August 6, 1984
84042.026

Subject: Responses to Cygna Design Control, Pipe Support, and Pipe Stress
Questions
Comanche Peak Steam Electric Station
Independent Assessment Program - Phase 3
Texas Utilities Generating Company
Job No. 84042

COMANCHE PEAK STEAM ELECTRIC STATION
CPSSES CYGA REVIEW QUESTIONS
(PIPE SUPPORTS)

Figure 1 Mathematical models for TUSI cable tray support study

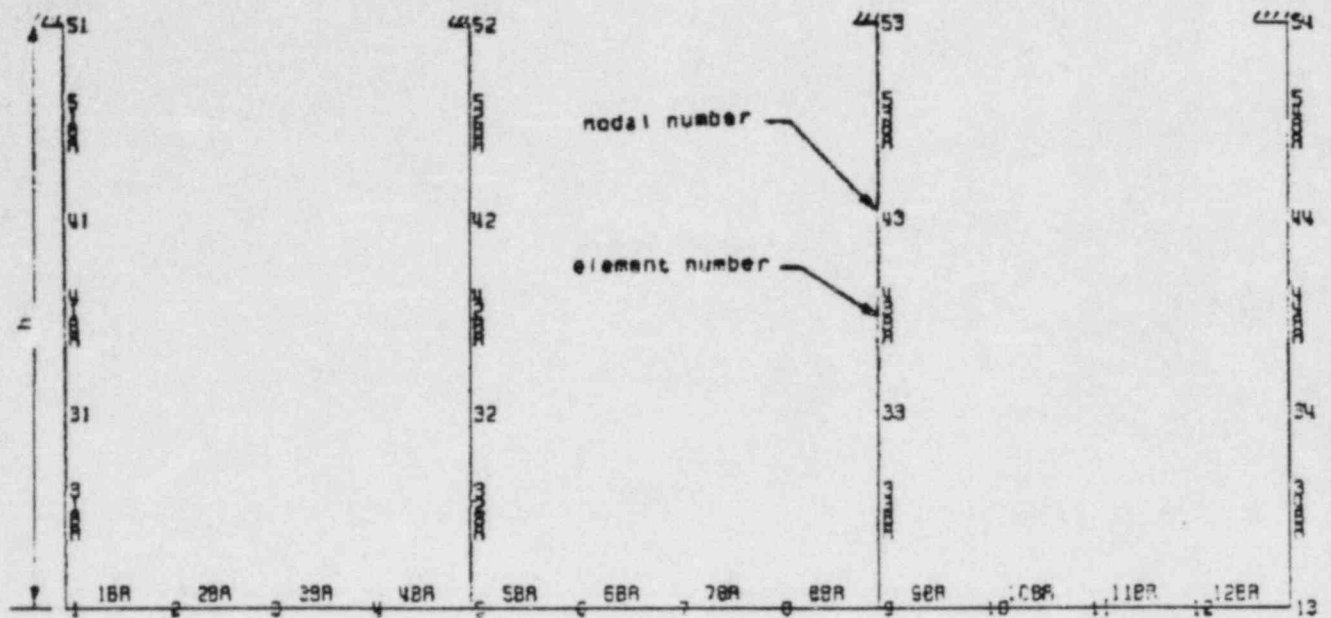
A model as shown in Figure 1 is used for the present study. The horizontal beams represent the cable trays, while the vertical columns simulate the supports. Time-history dynamic analysis is performed to evaluate more accurately the dynamic responses. In order to obtain the most conservative results from the dynamic analysis, the stiffnesses of the supports are adjusted so that the fundamental frequency of the cable tray system will be within 1% of the frequency corresponding to the peak input spectrum. The spectrum broadening effect is thus included in this evaluation because the model for the cable tray system will always be subjected to the peak spectrum acceleration.

6) The model used in this study (Figure 1) represents cable trays by a single beam which, implies that all trays are identical and vibrate in phase. However, one fully loaded support may have several different sizes of trays located at different elevations. Hence, it is expected that out-of-phase vibration will occur and the induced support forces and moments

Based on the results shown in Table 2, we can conclude that the use of a factor of 1.0 times the response spectrum peak which was used for the CPSES cable tray support design is conservative. In addition, additional conservatism actually exists as explained in section 3, "Discussion." No attempt has been made to quantify this additional conservatism; however, it is expected that any as-built case-by-case dynamic analysis of the cable tray system will indicate that the actual factor is less than the 1.0 - for CPSES design the 1.0 factor was conservatively used.

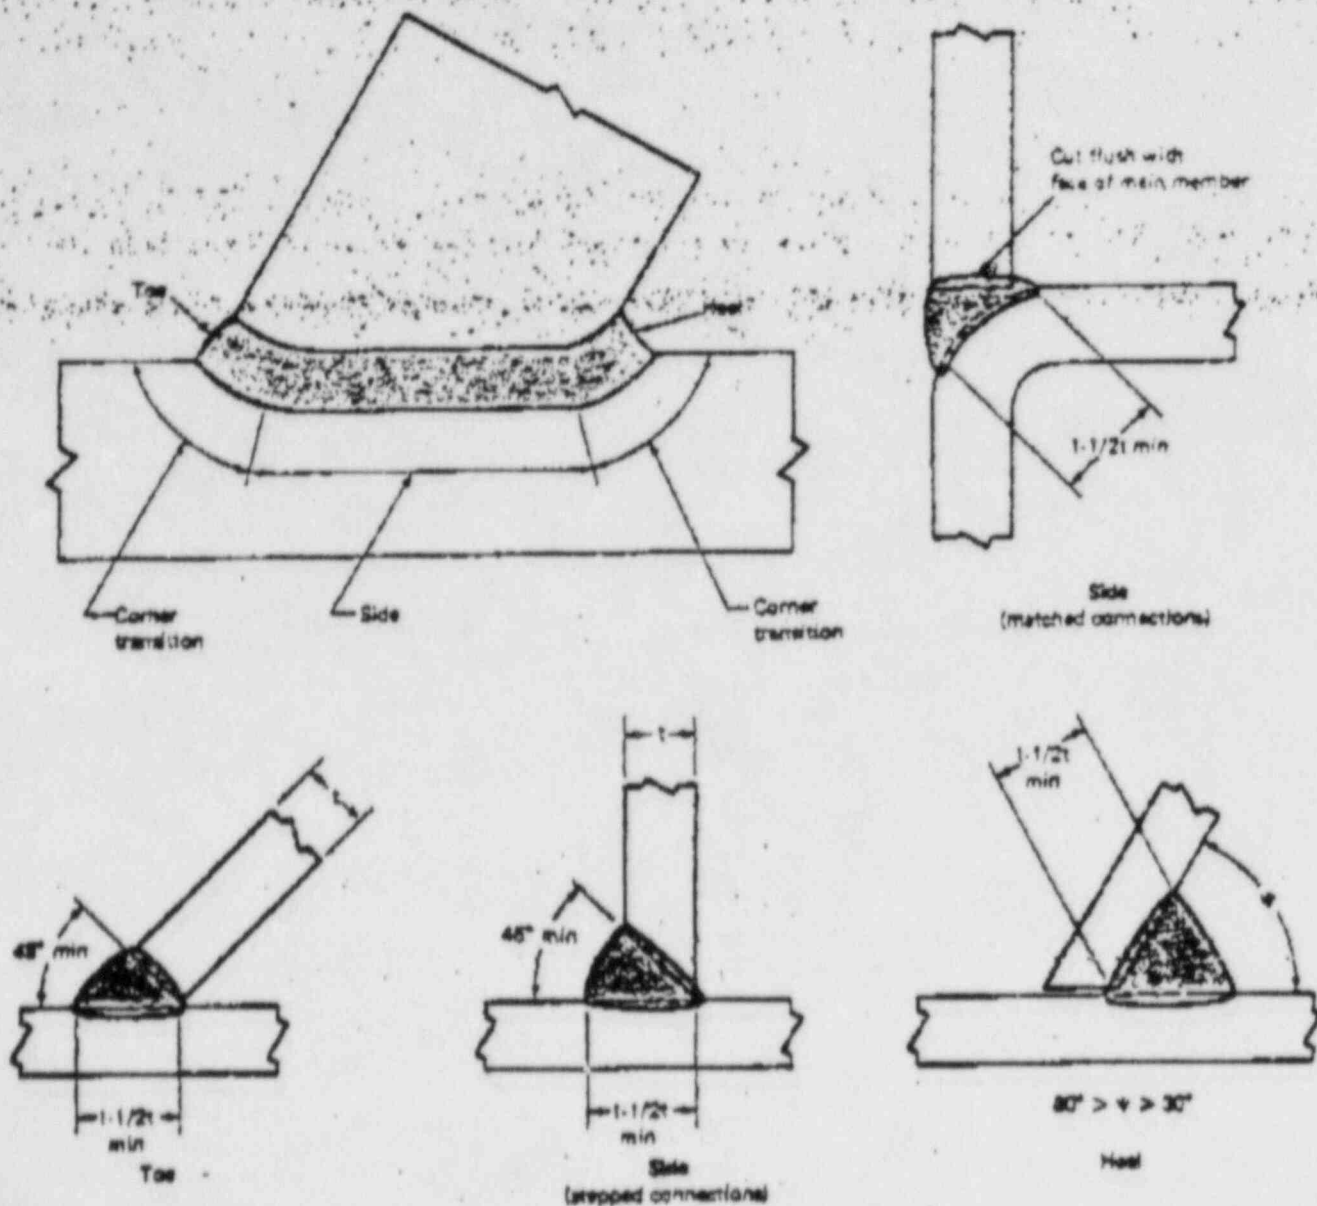
- a) Per AWS D1.1, 1979 edition, figure 10.13.1.3B, an effective throat of t is specified (see attached). Based on the geometry of the joint, $t_e=t$ is a reasonable value.*
- b) Calculation of weld effective throat (in any joint) is based on the shortest distance from the root of the weld to the face of the weld. For a flare bevel with a fillet cap, the engineer uses this approach in calculating t_e . The example supplied to CYGNA for MS-1-003-013-C72K, shows this calculation is done.
